**AMENDMENTS TO THE DRAWINGS**

The application has been amended in accordance with the Notice of Draftsperson's Patent Drawing Review, dated February 9, 2006. More particularly, the modifications requested to figures 1, 2, and 5 have been made.

FIGURE 1

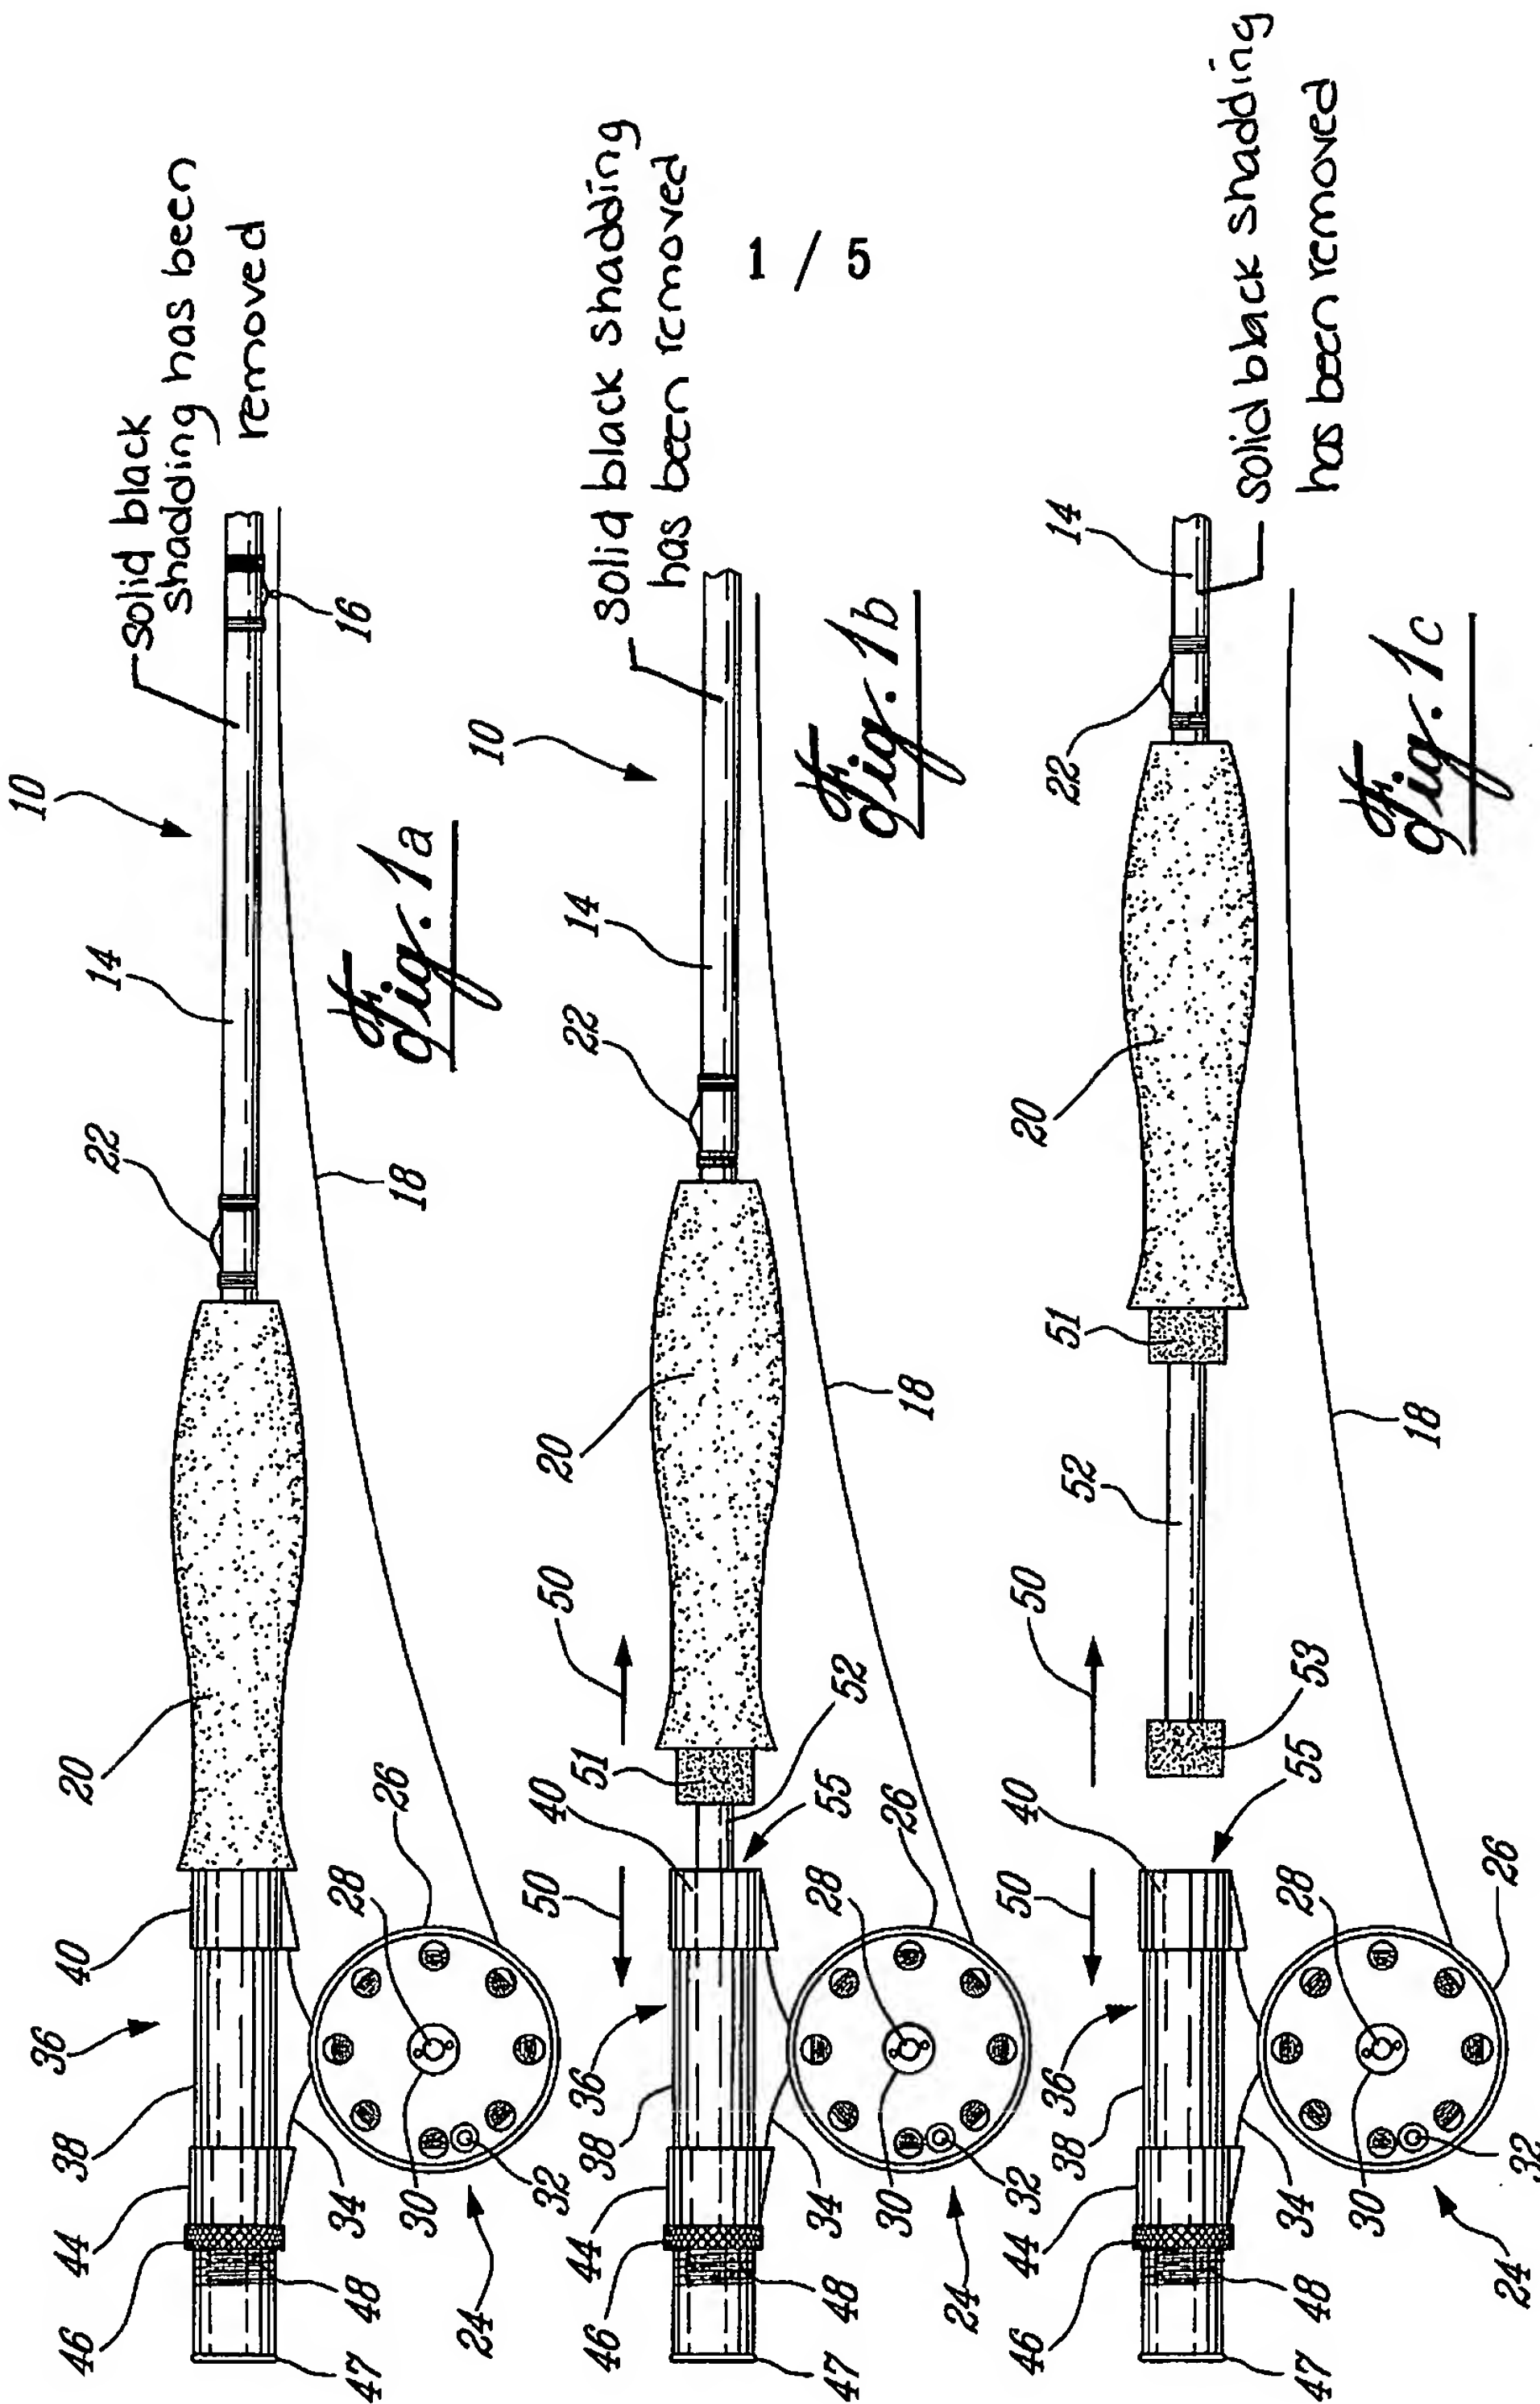
In figure 1, the solid black shading in the rod 14 has been removed.

The figures 1, 2, 4, and 5 have been renumbered Fig. 1a, Fig. 1b, Fig. 1c, Fig. 2a, Fig. 2b, Fig. 4a, Fig. 4b, Fig. 5a, Fig. 5b, and Fig. 5c respectively.

Fig. 3

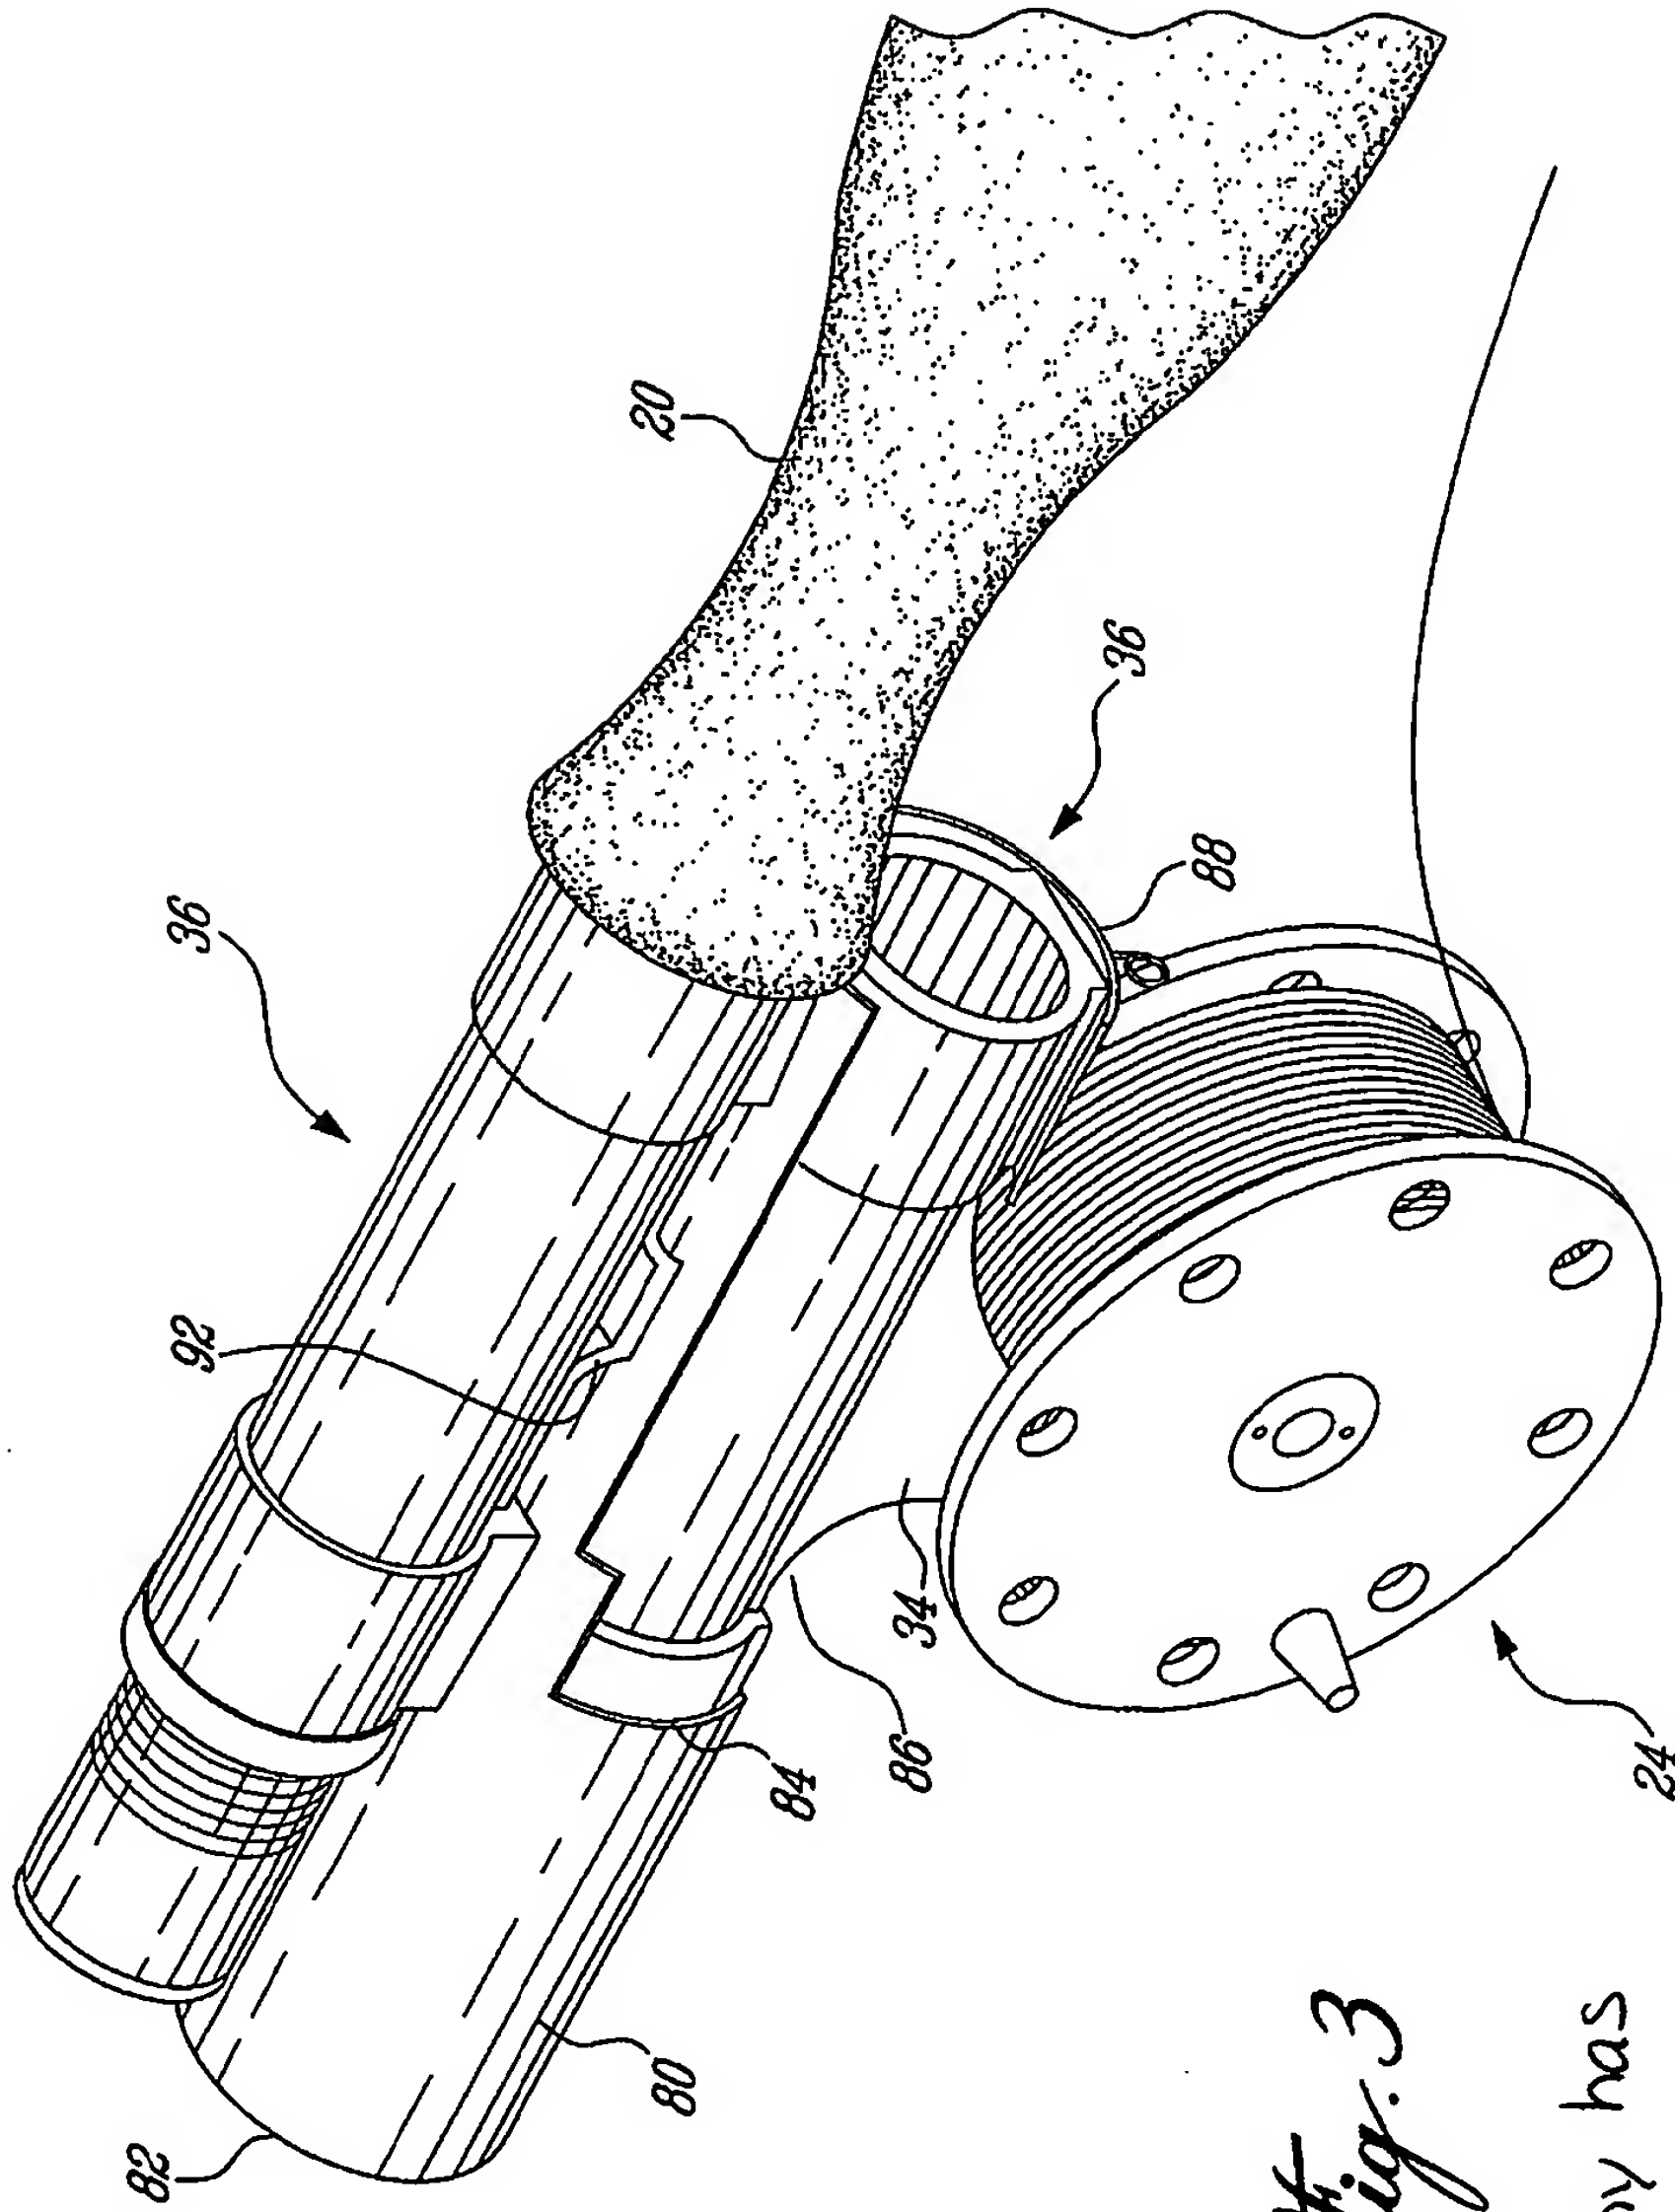
In figure 3, the calligraphy has been modified to correspond to the calligraphy of new figures 1, 2, 4 and 5.

calligraphy has  
been modified
